### Global Response GR-6

#### Alternatives

A number of commenters stated that the Draft EIR should consider additional alternatives to the JVR Energy Park Project (Proposed Project) and suggested alternatives that would purportedly reduce the Proposed Project's significant and unavoidable impacts to aesthetic and visual resources.

Proposed Project Simulation: Visual Simulation of the Proposed Project

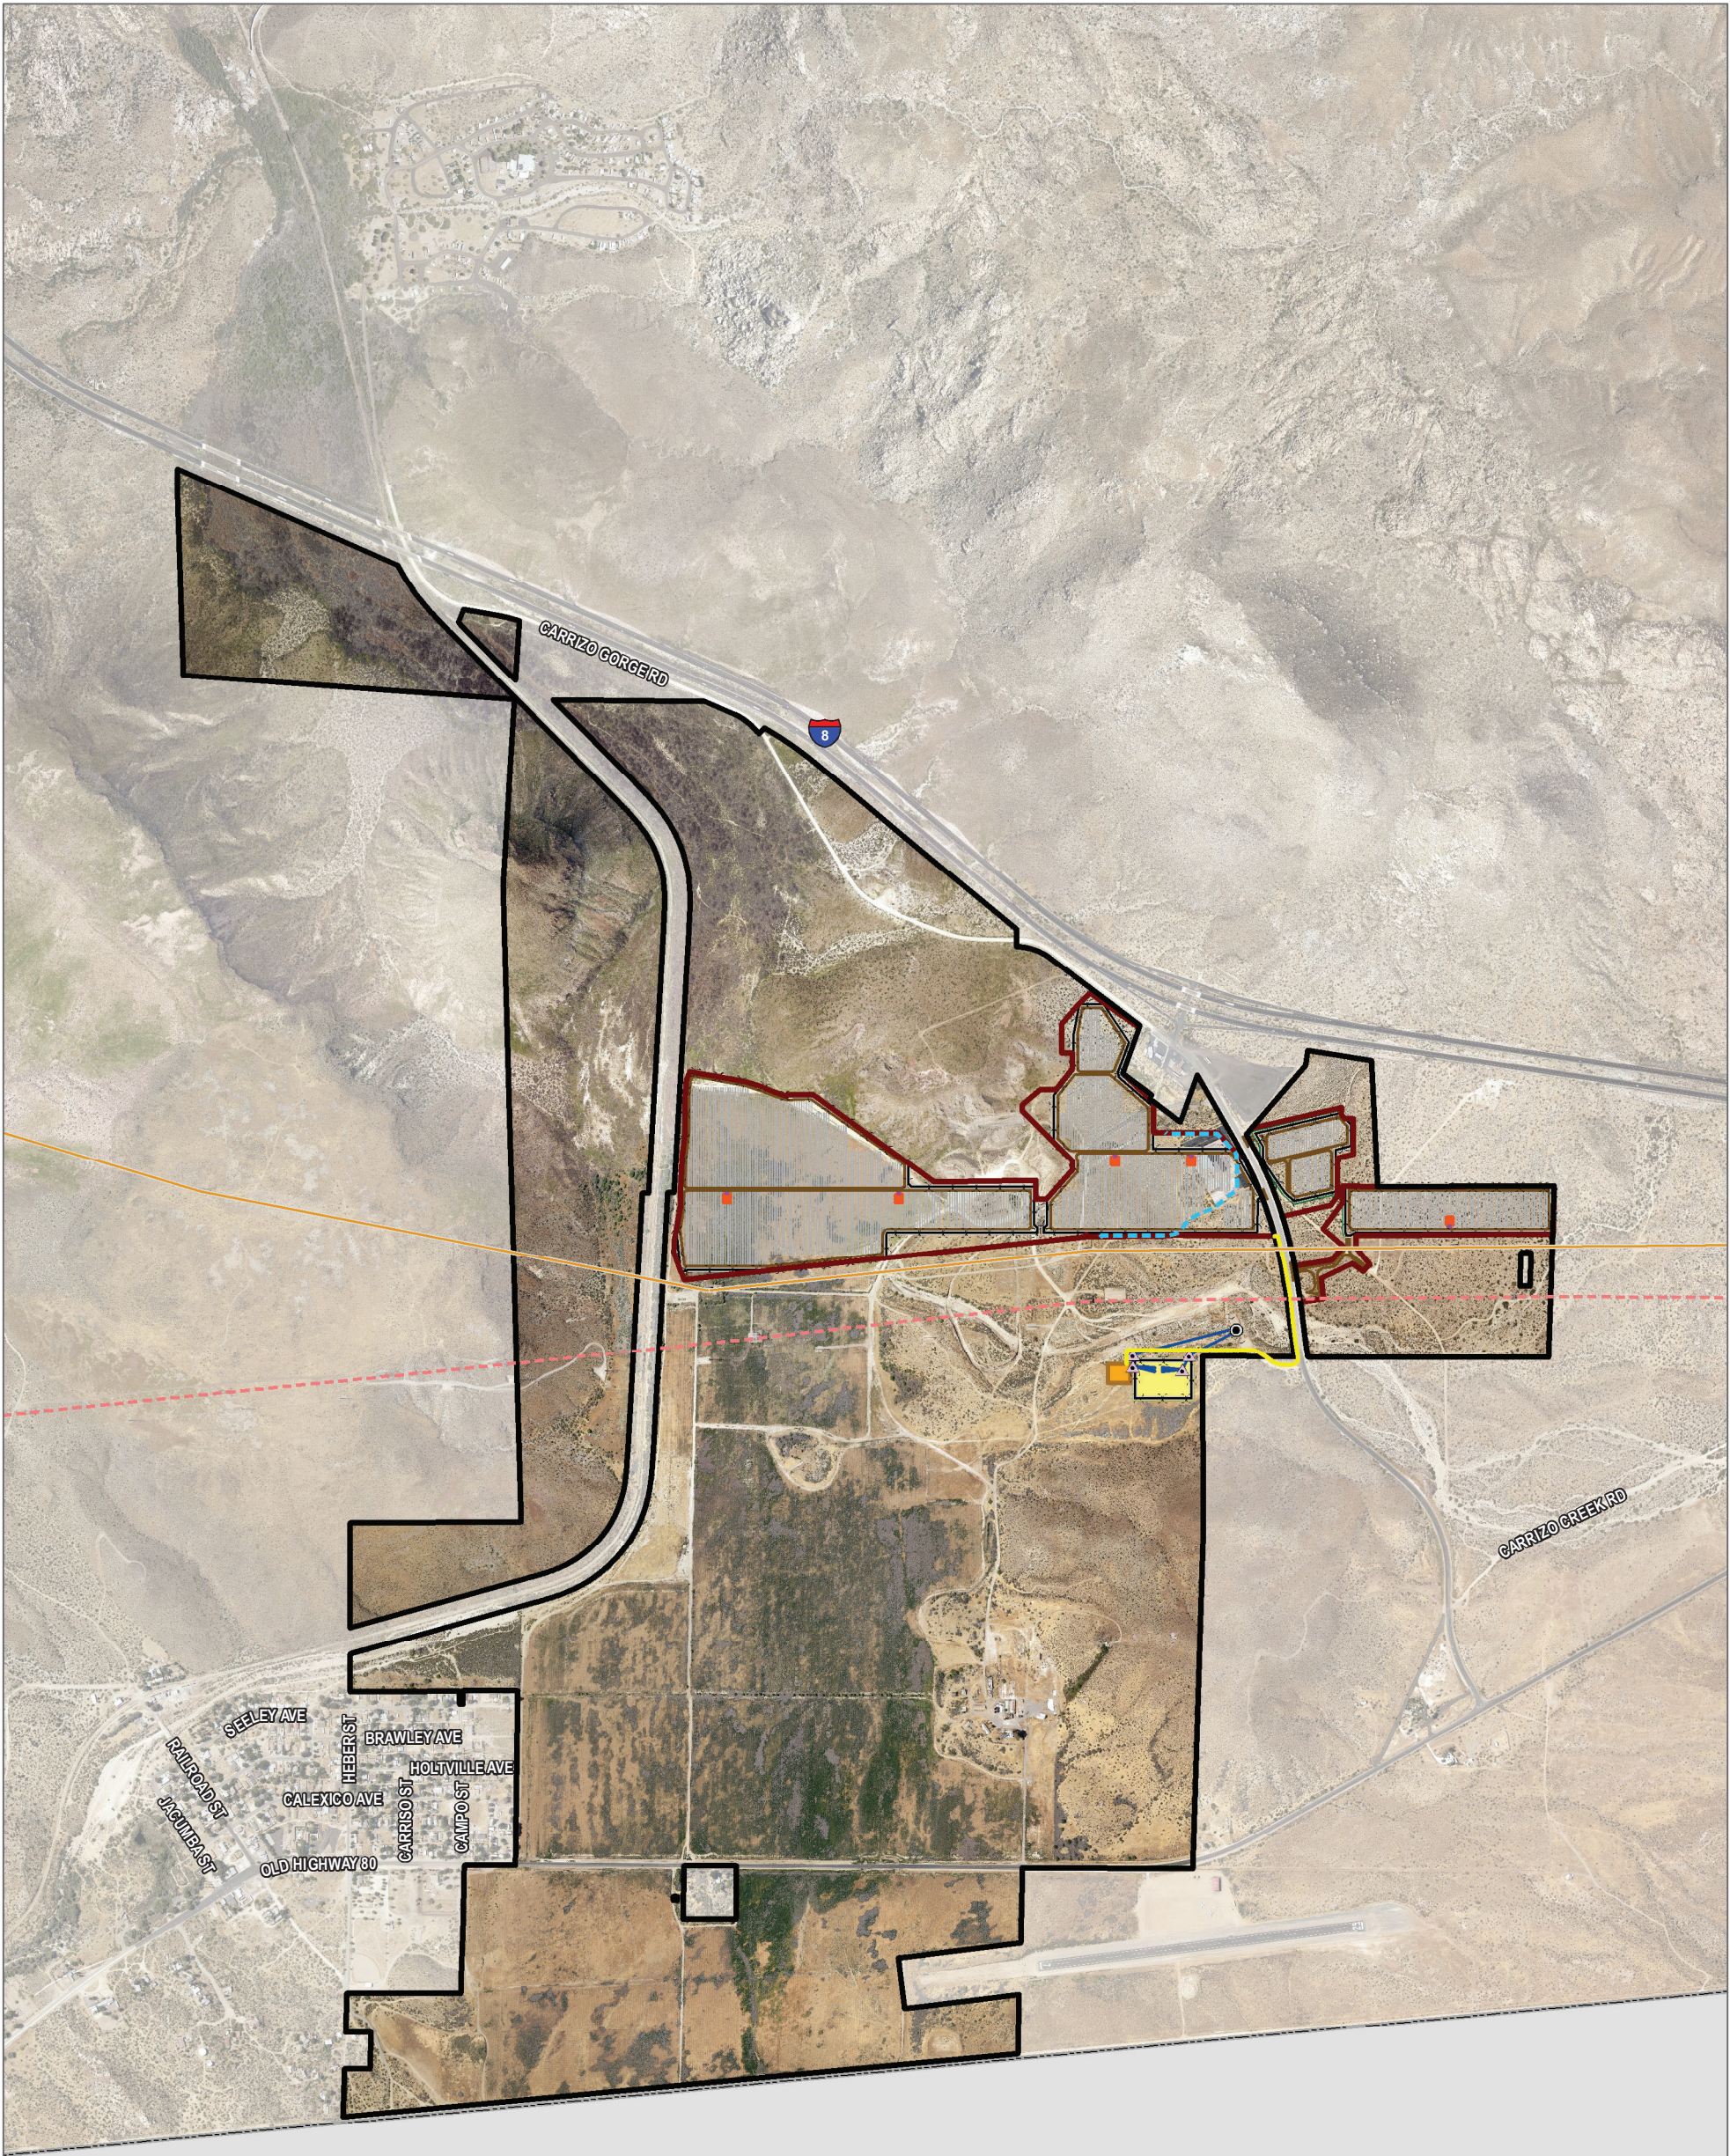
Commenters on the Draft EIR expressed concern about the location of the Proposed Project and questioned why it is not located somewhere else in the County or in Imperial County. As explained in the Draft EIR, “[t]he Applicant and County have explored a number of alternative locations throughout San Diego County and have screened these locations for their capability to meet the Project objectives, including the presence of excellent solar attributes. There are no other known readily available parcels of undeveloped land of similar size in the eastern portion of the County that could accommodate development of the Proposed Project that have not already been considered and rejected for development of a similar solar project, provide adequate site accessibility, and/or could be acquired by the Applicant within a reasonable period of time. Ultimately, the Applicant does not own or have the ability to easily acquire other sites in the San Diego region in order to provide an Alternative Location project.” Further, the County does not have jurisdictional control over alternative locations in Imperial County. Accordingly, alternative

In response to comments on the Draft EIR, the Community Buffer Alternative was revised in the Final EIR to include increased setbacks along Old Highway 80 and adjacent to Jacumba Community Park. As stated in the Final EIR, these increased setbacks would substantially reduce impacts to visual character and quality of the Jacumba community.

A comparison of views from the Jacumba community to the Proposed Project and to the Community Buffer Alternative is shown in Figure GR-6-1. As shown therein, for the Proposed Project viewers from the community would be approximately 75 feet away from the Proposed Project’s nearest solar arrays with an 8.8-degree angle of obstruction. This results in noticeable blocking of views across the Project site such that the hill and valley terrain of the surrounding area are blocked from view. Under the Community Buffer Alternative, viewers would be approximately 330 feet away from the Proposed Project’s nearest solar arrays (300 feet to the fence line). At this distance, the obstruction of the viewshed would be reduced to approximately 2.1

degrees. Accordingly, the Community Buffer Alternative would result in a 77% reduction in viewshed obstruction from the Jacumba community. As such, the EIR concludes that the Community Buffer Alternative would substantially lessen **Impact AE-1** (Existing Visual Character and/or Quality) and **Impact AE-2** (Valued Visual Character of Community) as well as the related cumulative impacts—**Impacts AE-CU-1** (Cumulative Visual Character and/or Quality) and **AE-CU-2** (Cumulative Valued Visual Character of Community), but not to less than significant. Further, the Community Buffer Alternative would also reduce the total mitigation requirement for habitat, meaning less biological open space easements would be required under mitigation measure **M-BI-3**. This reduction would lessen the mitigation measure's impact on mineral resources, but not to less than significant. The Community Buffer Alternative would reduce the Proposed Project's potentially significant impacts to additional resource areas as discussed further in Section 4.4 of Chapter 4, Alternatives. Further, the EIR concludes that the Community Buffer Alternative would generally meet all of the Proposed Project's objectives, although to a lesser extent than the Proposed Project.

Existing View Southwest from mesa landform south of Table Mountain

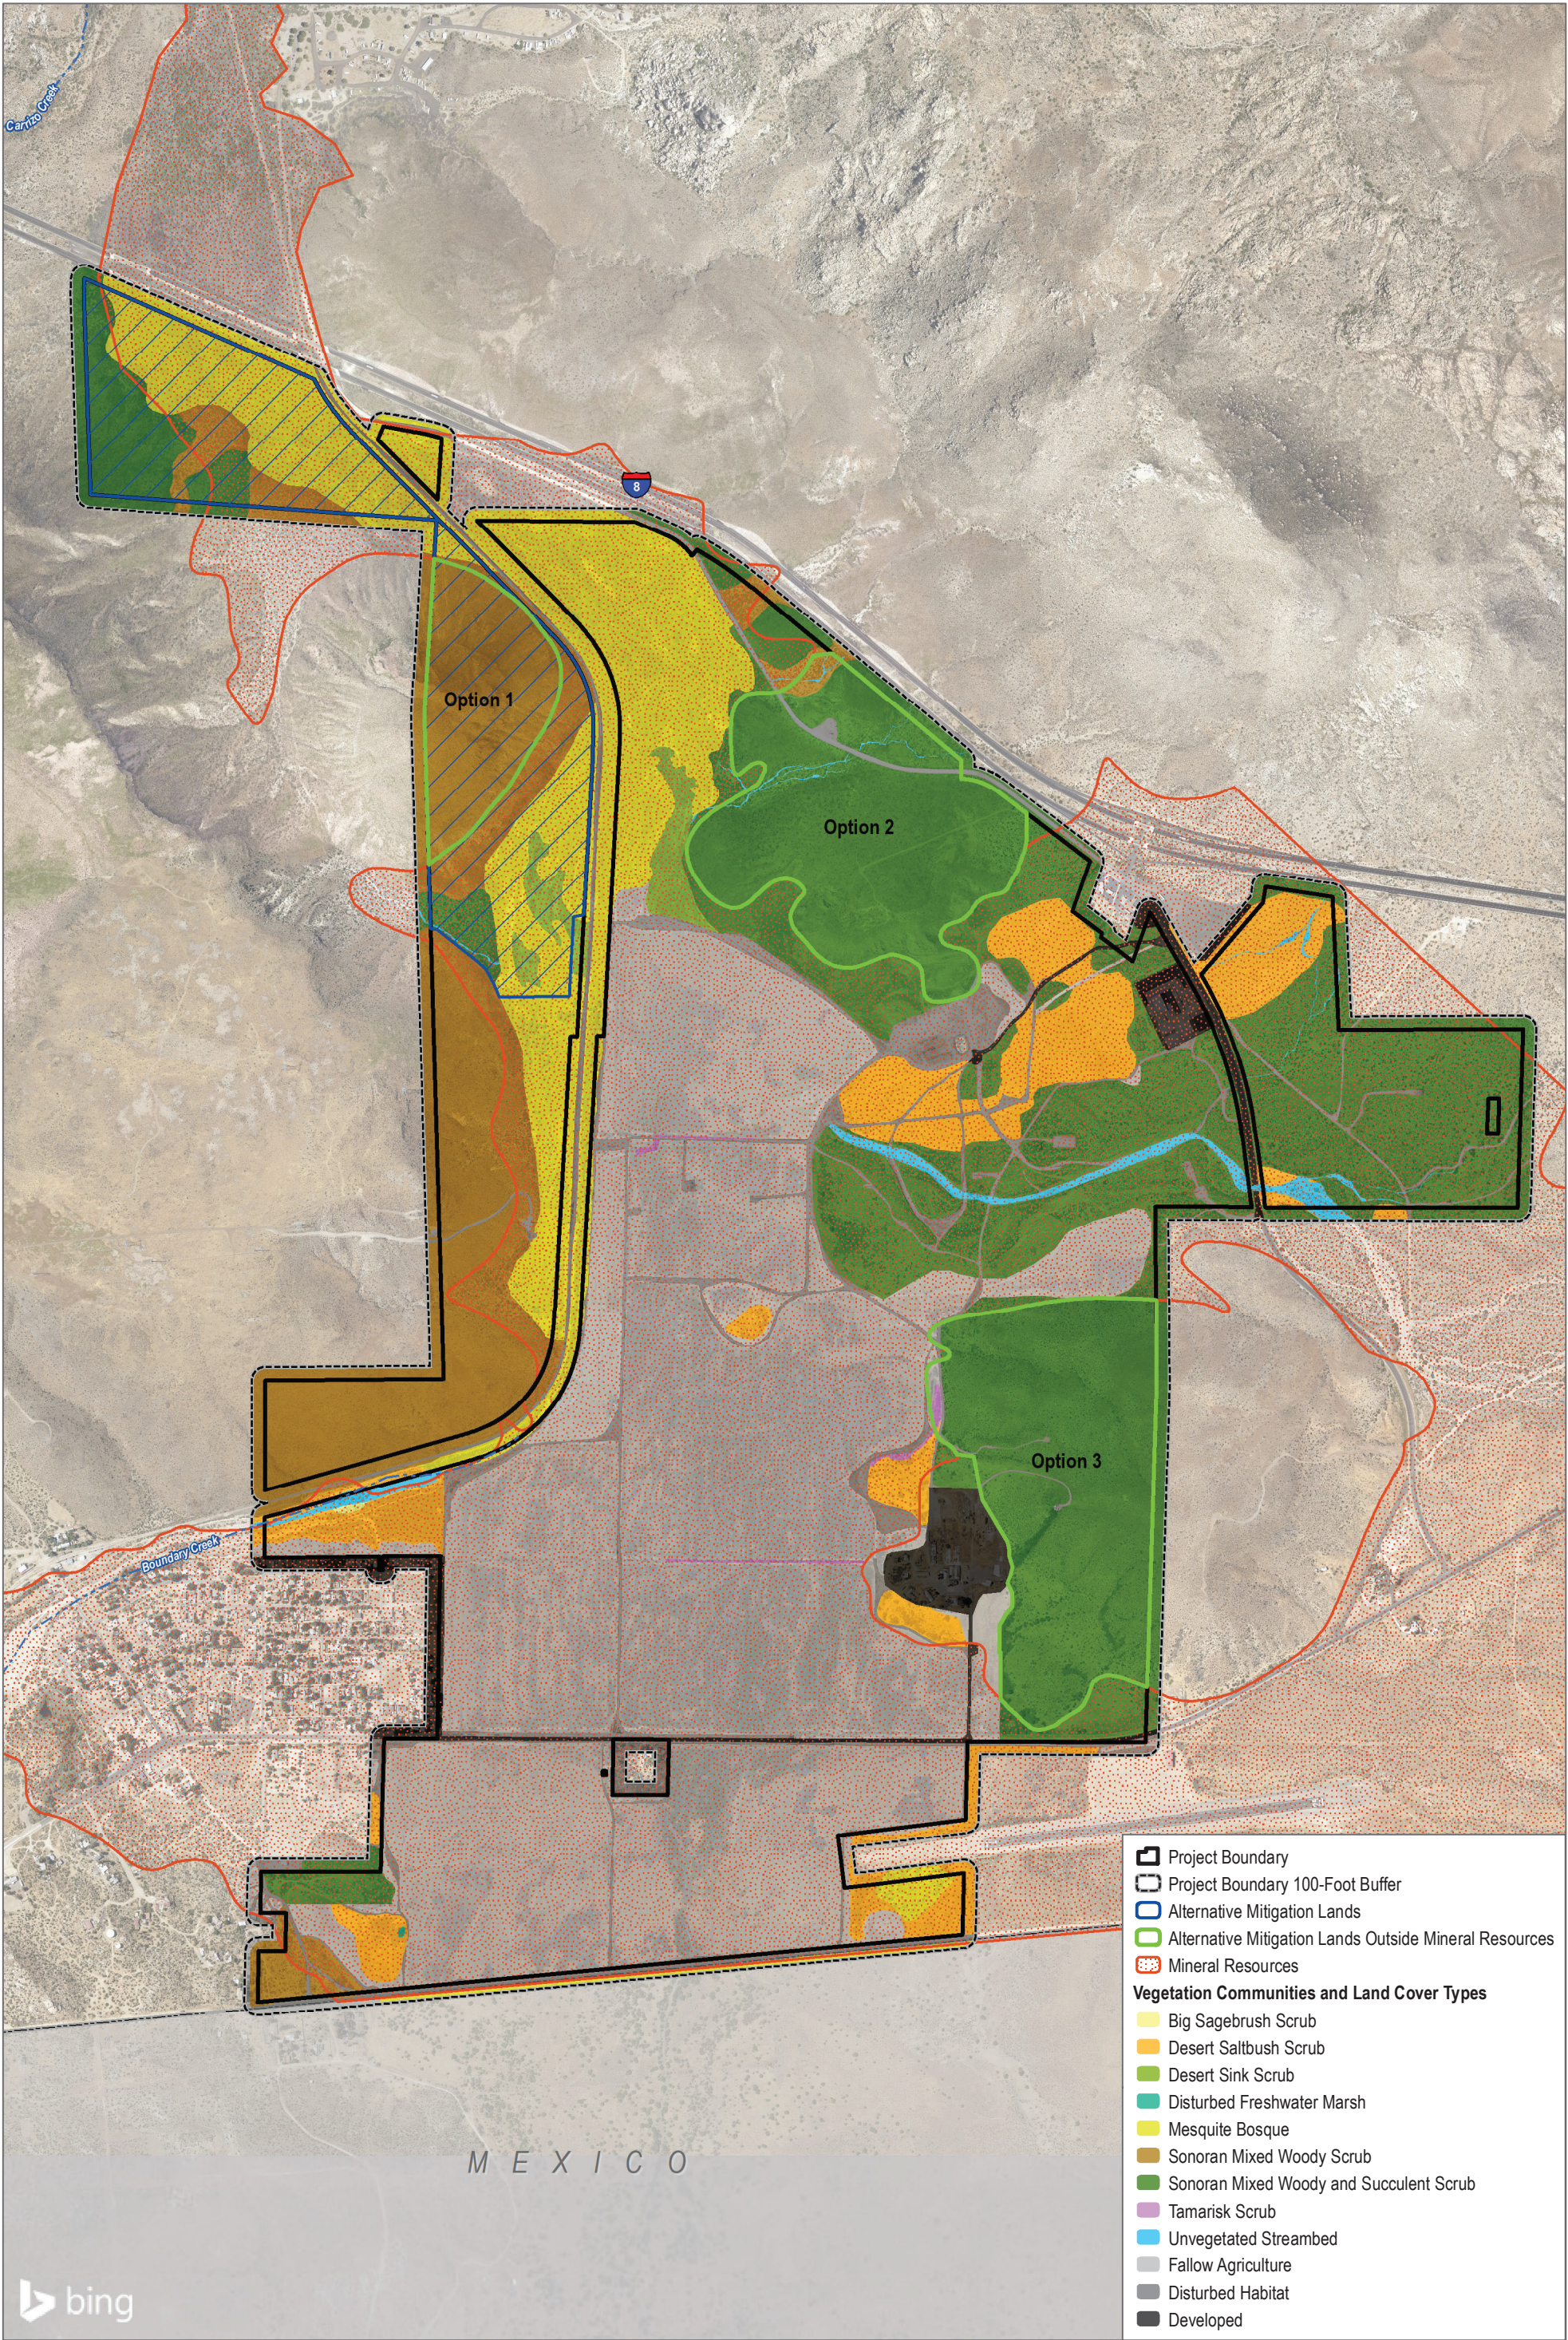
While the Draft EIR analyzed a reasonable range of alternatives and satisfied the requirements of CEQA, commenters proposed three additional alternatives: Reduced Project-Northern Focus Alternative; Jacumba Community Alternative; and the Reduced Panel Height Alternative. These additional alternatives are discussed further below.

While the area of solar panels would be reduced, the long-distance views from State Park lands to the west, Round Mountain, Airport Mesa and Table Mountain areas would continue to have a highly visible and prominent change from converting 152 acres of open land to dark solar panels. (See Figures GR-6-4 and GR-6-5.) Thus, the Reduced Project Alternative - Northern Focus Alternative would have significant view **Impacts AE-6** (State Park Lands to the west), **AE-7** (Round Mountain), **AE-8** (Airport Mesa) and **AE-9** (Table Mountain), and this suggested alternative would not avoid view Impacts **AE-6 to AE-9** of the Proposed Project.
